From: David E. Williamson  
Sent: Wednesday, December 15, 2004 11:42 AM  
To: kbowling@majortool.com  
Cc: NKHFlowen@aol.com; Phil Heitzenroeder  
Subject: FW: Drawing Vs. Model Questions

## Project response to communication from K. Bowling 12/10/04

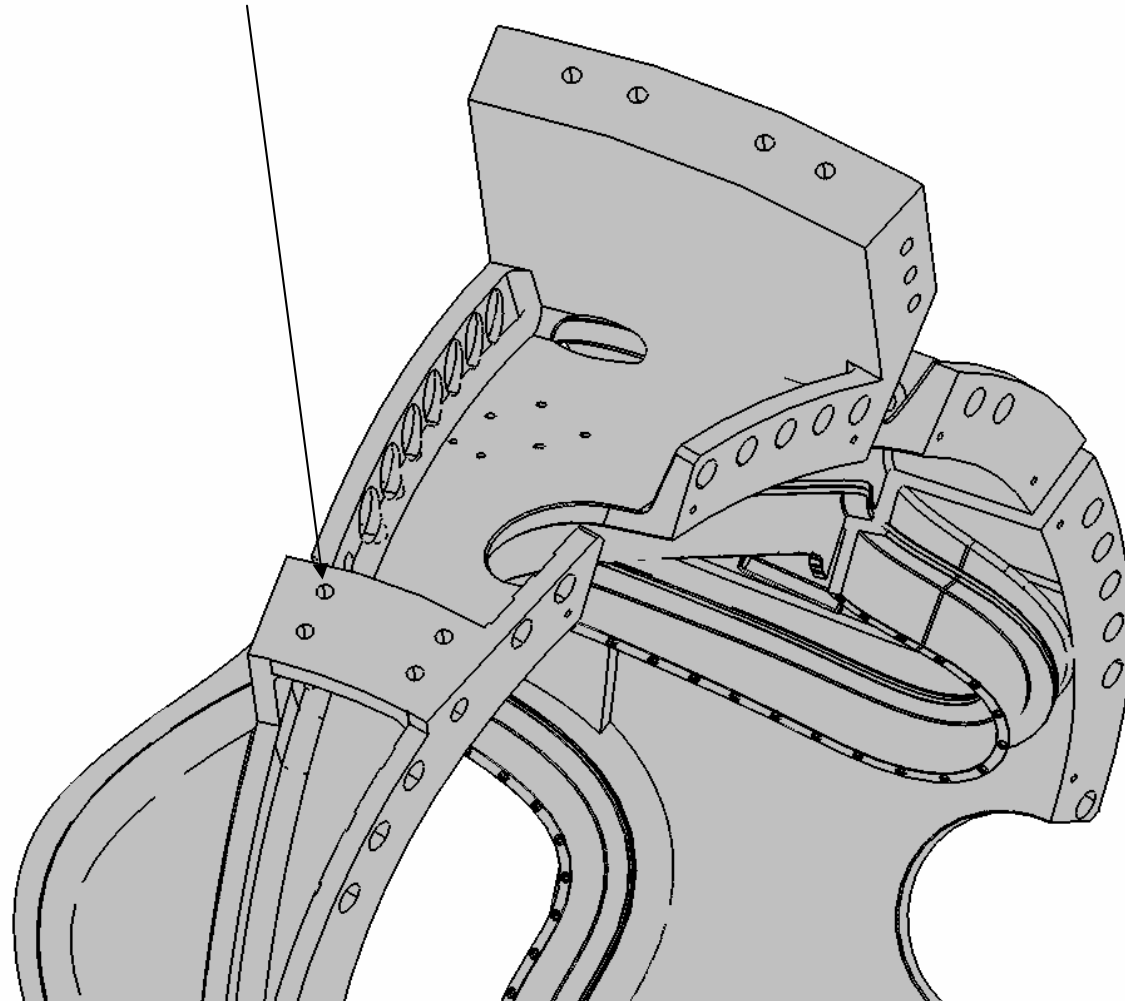
Item	A	B	C	Sheet/ Zone	Drawing	CAD Model	Status	Project Response
	Count	Count	Count					
2	16		8	3	Ø.875 TAP DRILL	Ø1.0	OK Ref tap drill Ø	Drawing is correct. Model hole size will be changed to 0.875-in diameter.
	"		"	"	1-8 TAP

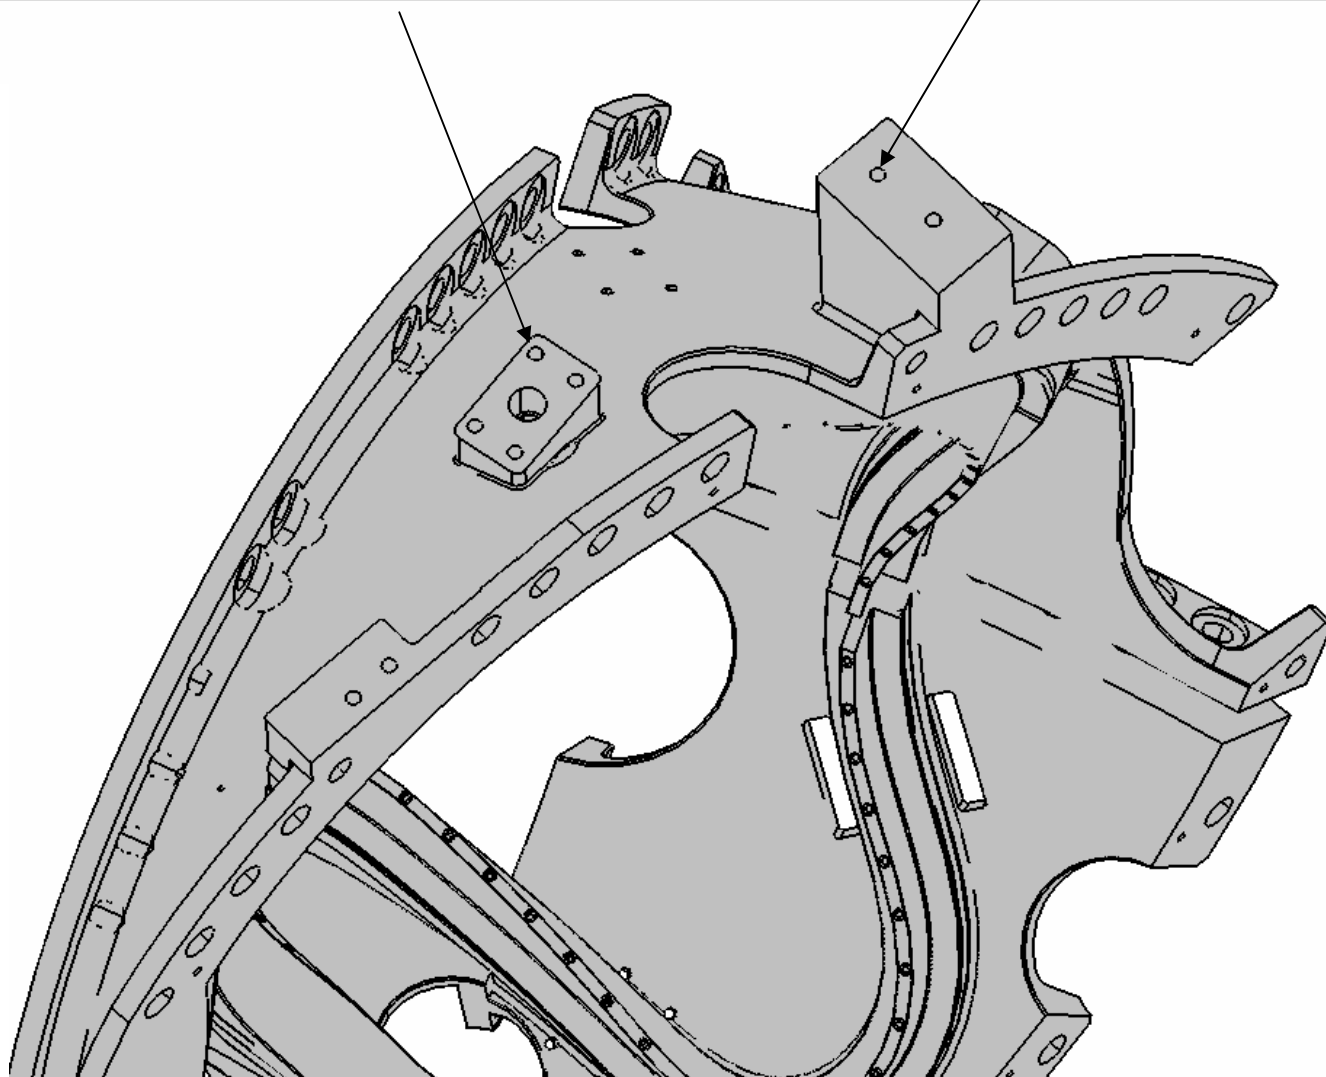
Item	A	B	C	Sheet/ Zone	Drawing	CAD Model	Status	Project Response
	Count	Count	Count					
3		8		3 C5	Ø.875 TAP DRILL	Ø.766	open	Drawing is correct. Model hole size will be changed to 0.875-in diameter.
		"		"	1-8 TAP			
4		8		3 C6	Ø.875 TAP DRILL	Ø.755	open	Drawing is correct. Model hole size will be changed to 0.875-in diameter.
		"		"	1-8 TAP

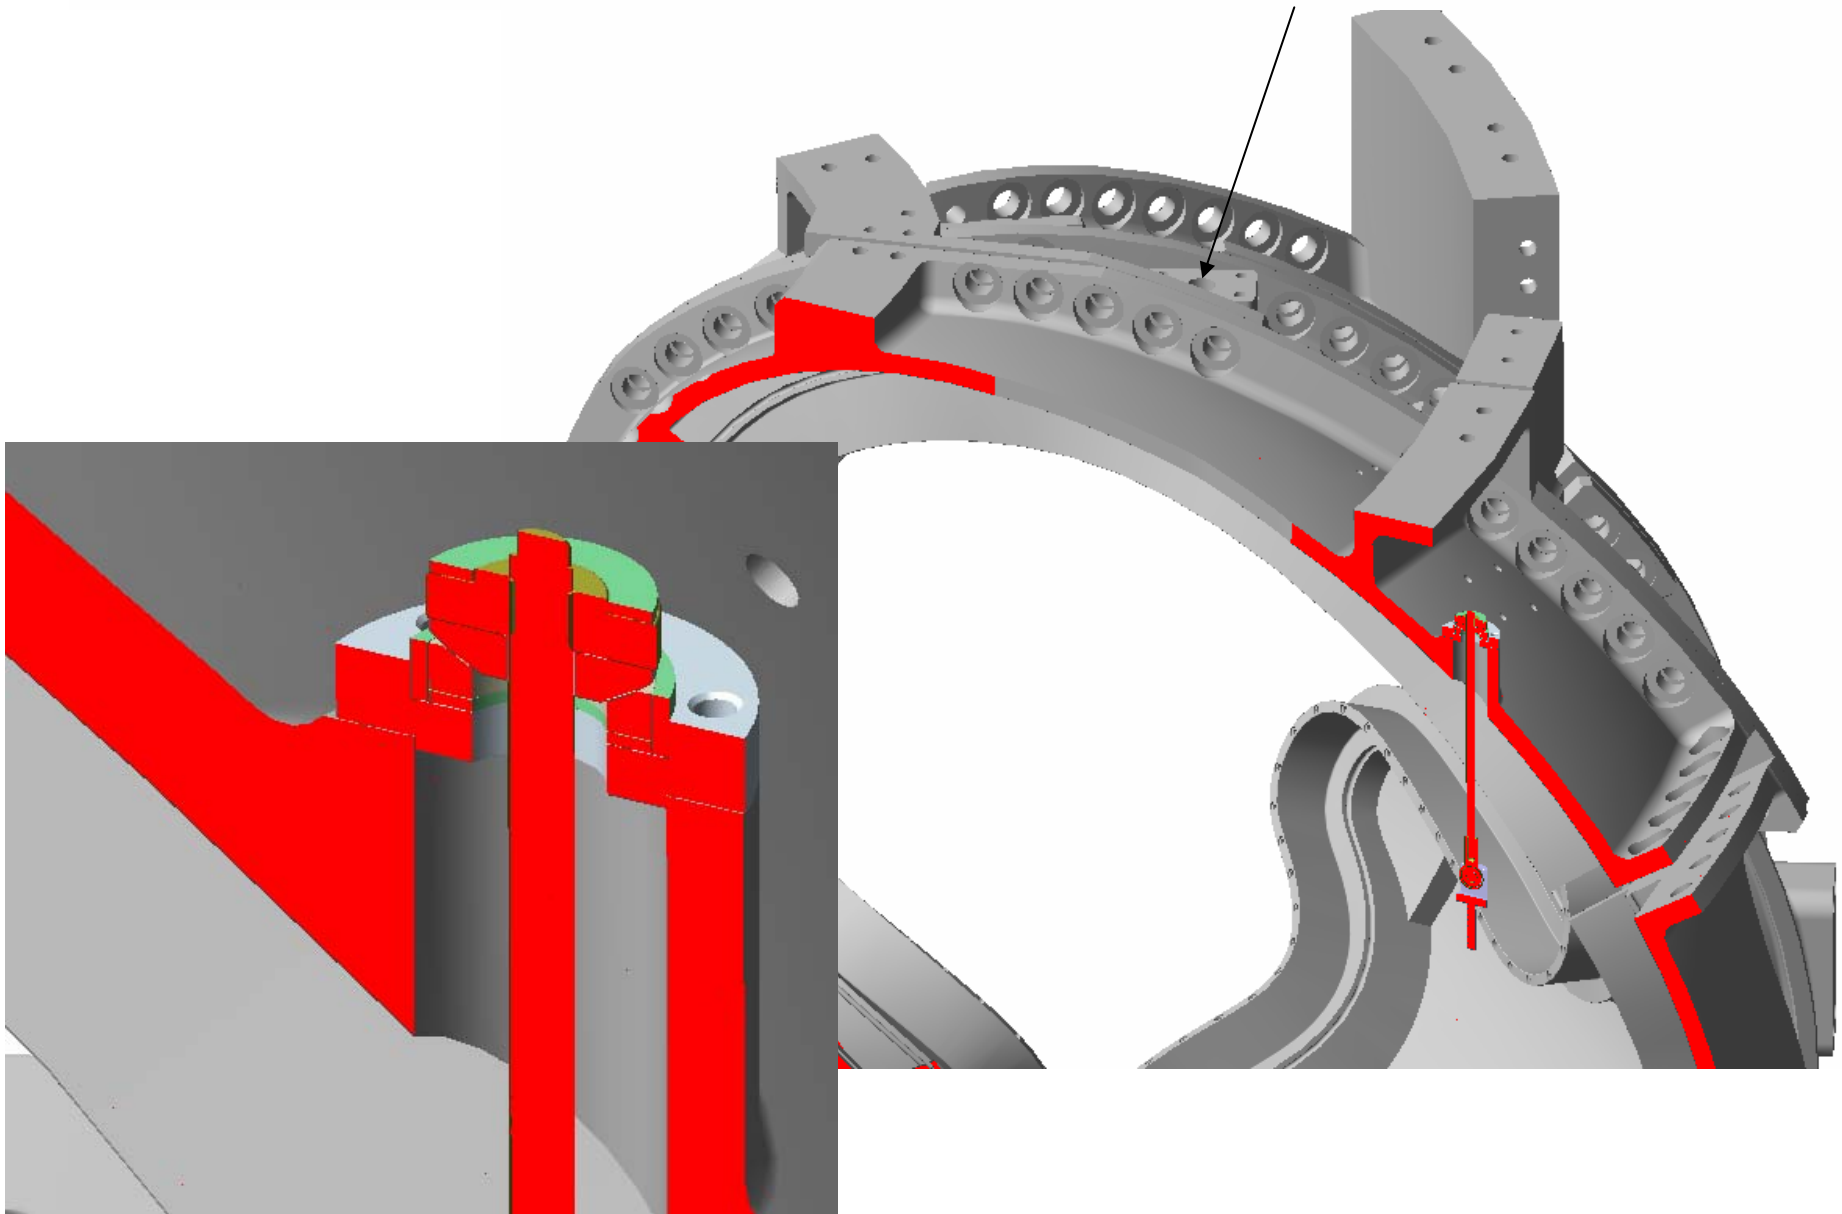
Item	A	B	C	Sheet/ Zone	Drawing	CAD Model	Status	Project Response
	Count	Count	Count					
5		2		3 F2	Ø1.48 X 5 Thru (5.0 DP)	Ø1.5	open	Change to 2.5-in dia thru, like Drw -114, Sht3, D2. Tapped holes next revision.
		"		"	Ø1.86 X 2.5 DP CBORE	Ø1.875	open

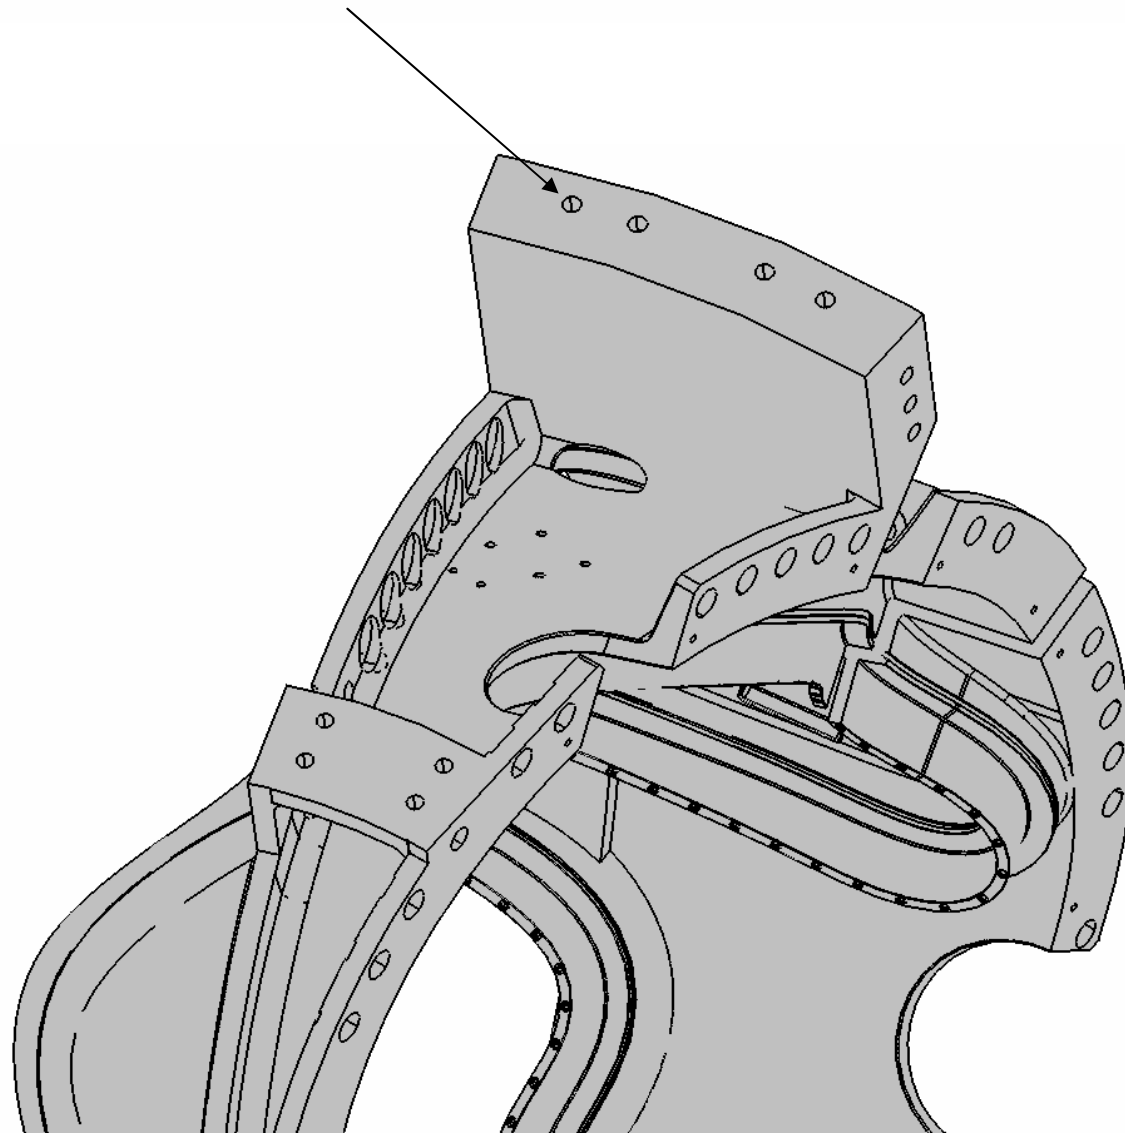
Item	A	B	C	Sheet/ Zone	Drawing	CAD Model	Status	Project Response
	Count	Count	Count					
6			8	3	Ø1.125			Drawing callout is correct.
			"	"	Ø3.0 BACK SPOT FACE	not in model	open

## FLANGE INTERFACE A-A (symmetry about midplane)

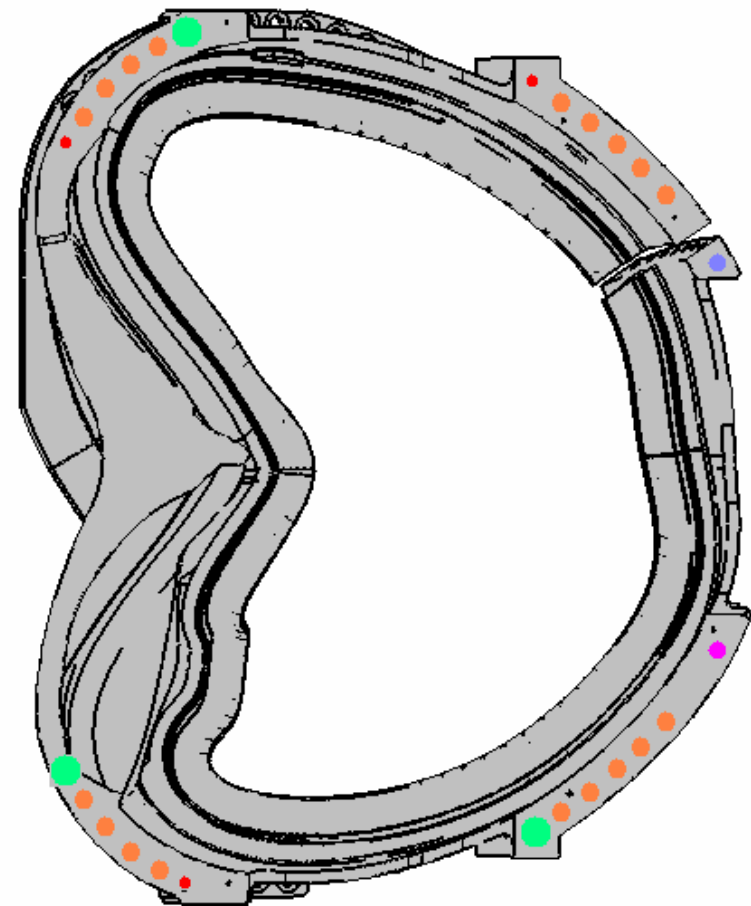
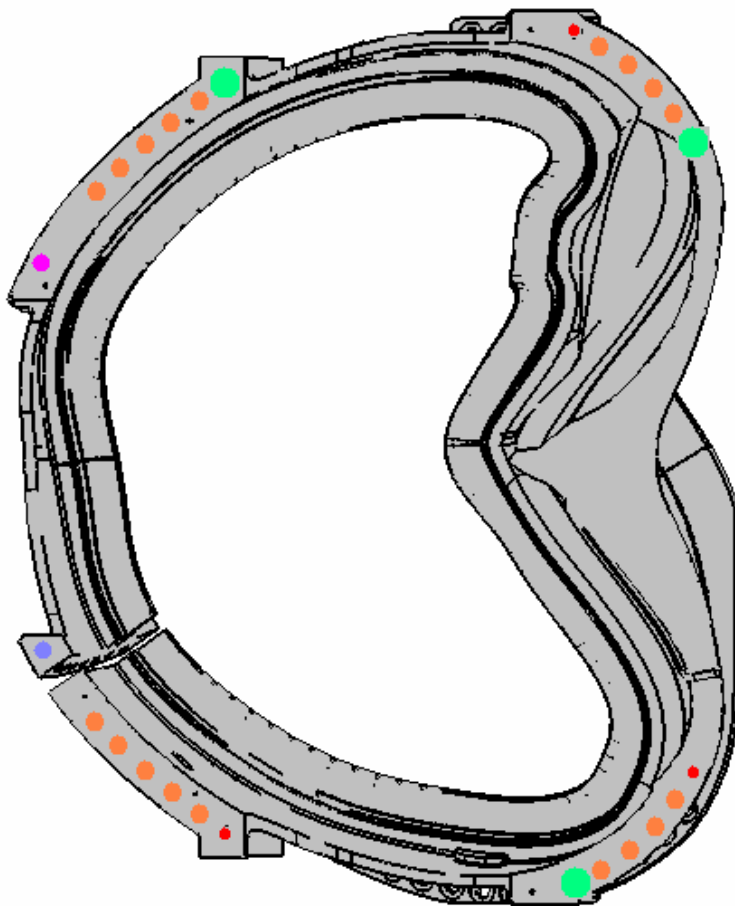
- ↔ ●  $\phi 1.875$  DRILL,  $\phi 3.25$  BACK SPOT FACE > SAME
- ↔ ●  $\phi 1.375$ -6UNC THRU >  $\phi 1.875$  DRILL,  $\phi 3.0$  BACK SPOT FACE
- ↔ ●  $\phi 3.0 \times 1$  DP CBORE,  $\phi 1.5 \times 1.5$  DP / THRU > SPHERICAL .75R

7	18	24	17	4	Ø1.875 DRILL			Sheet 4 - See Figures 6-9 for flange-to-flange hole template. Drawing notes to be clarified, models will be revised to match figures.
	"	"	"	"	Ø3.25 BACK SPOT FACE		2X type C 7.75 long	
	1	1	4	4	Ø1.875 DRILL			
	"	"	"	4 E4	Ø3.0 BACK SPOT FACE	Ø3.25	open	
	3			4	Ø.75 Thru (1.375 DP)	Ø1.50	open	
	3			4	Ø3 x 1 DP CBORE			
	6	10	20	4	Ø.201 x .5 DP			
		"	"	"	.250-20 TAP	no tap on A	open	
	"	"	"	"	Ø.507 x 82 Deg Chamfer			
			6	4	Ø1.125 DRILL			
8			"	"	Ø3.38 BACK SPOT FACE	Ø2.38	open	Sheet 5 - See Figures 6-9 for flange-to-flange hole template. Drawing notes to be clarified, models will be revised to match figures.
	1	3	4	5	Ø1.875 DRILL	check C5 Sec ZZ		
	"	"	"	5 D7	Ø3.0 BACK SPOT FACE	Ø3.25	open	
	3	3	2	5	Ø3 x 1 DP CBORE			
	3		2	5	Ø.75 x 2.33-B/ 2.0-C	Ø1.50	open	
			3	5	Ø1.5 X 1 DP			
	3			5	Ø1.5 X 1.33 DP			
				5	Ø1.125 DRILL			
			"	"	Ø3.38 BACK SPOT FACE	Ø2.38	open	
		7			Ø1.500 DRILL	Ø1.625	open

## FLANGE INTERFACE A-B

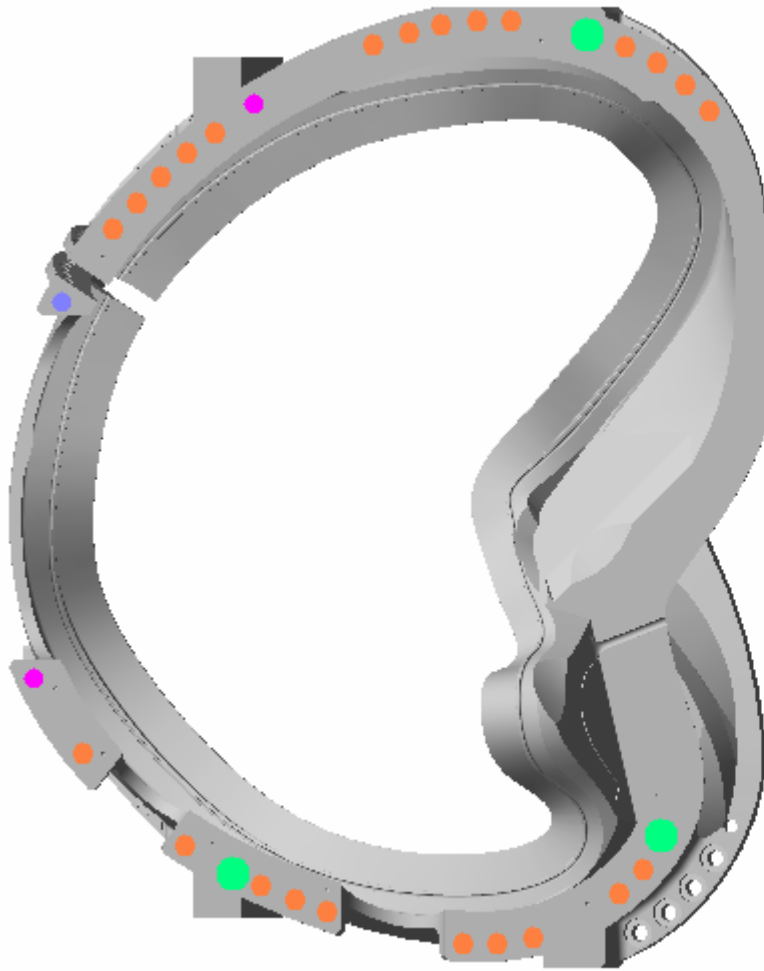
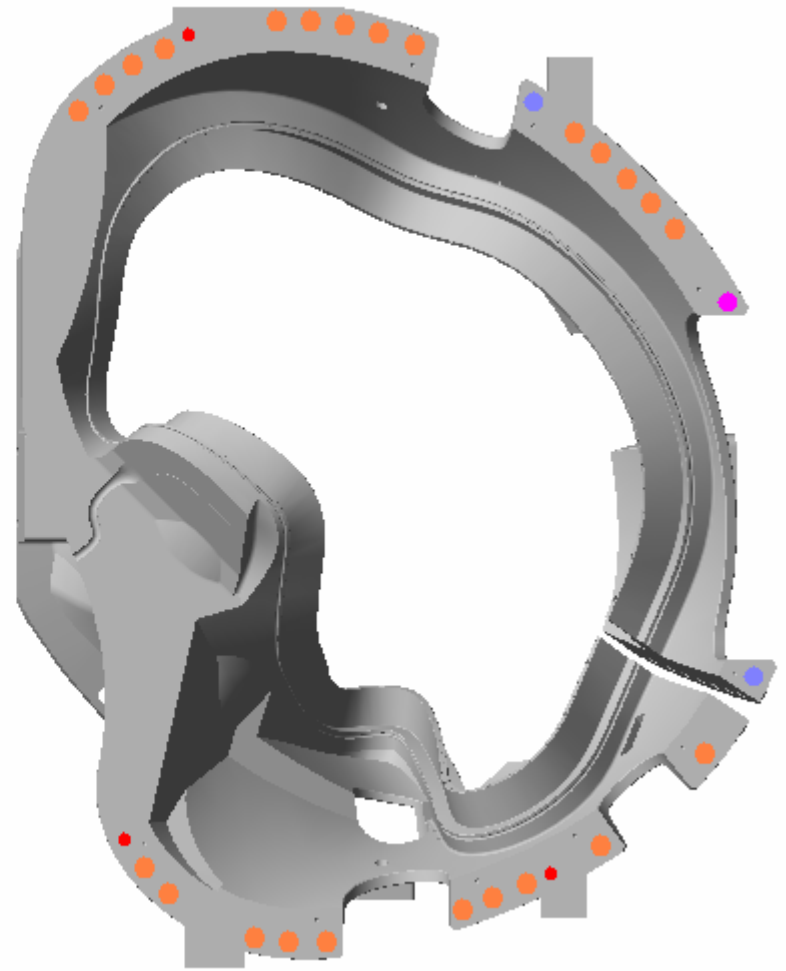
- ↔ ●  $\phi 1.875$  DRILL,  $\phi 3.25$  BACK SPOT FACE > SAME
- ↔ ●  $\phi 1.375$ -6UNC THRU >  $\phi 1.875$  DRILL,  $\phi 3.0$  BACK SPOT FACE
- ↔ ●  $\phi 3.0 \times 1$  DP CBORE,  $\phi 1.5 \times 1.5$  DP / THRU > SPHERICAL .75R

## FLANGE INTERFACE B-C

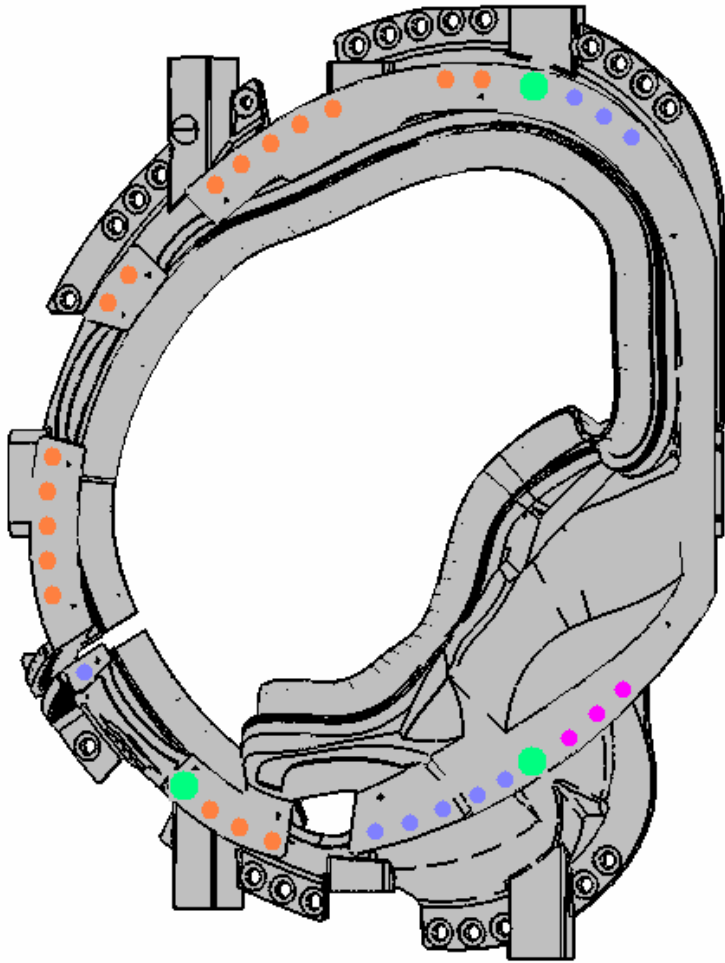
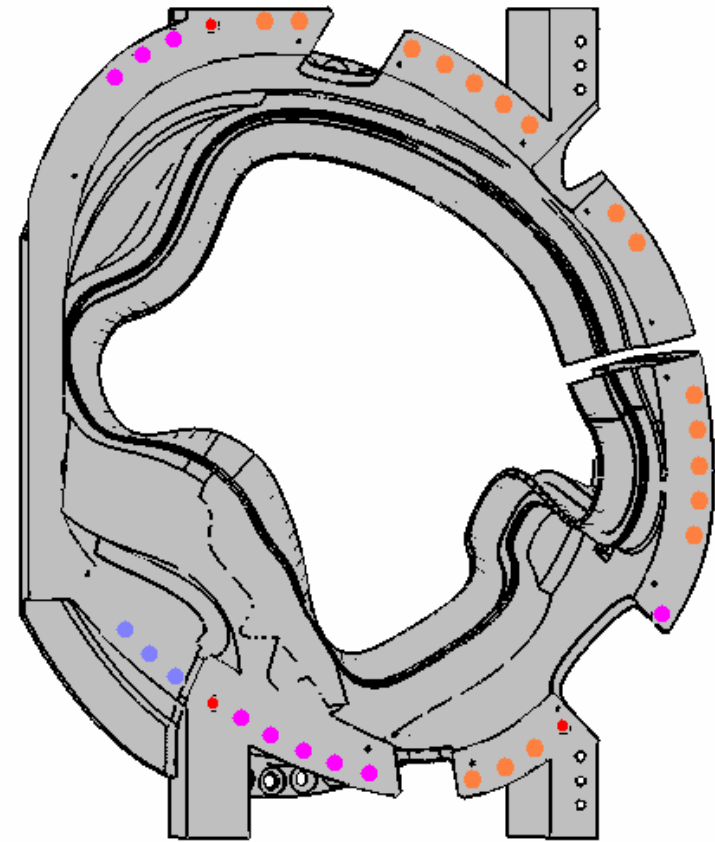
- ↔ ●  $\phi 1.875$  DRILL,  $\phi 3.25$  BACK SPOT FACE > SAME
- ↔ ●  $\phi 1.375-6\text{UNC}$  THRU >  $\phi 1.875$  DRILL,  $\phi 3.0$  BACK SPOT FACE
- ↔ ●  $\phi 3.0 \times 1$  DP CBORE,  $\phi 1.5 \times 1.5$  DP / THRU > SPHERICAL .75R
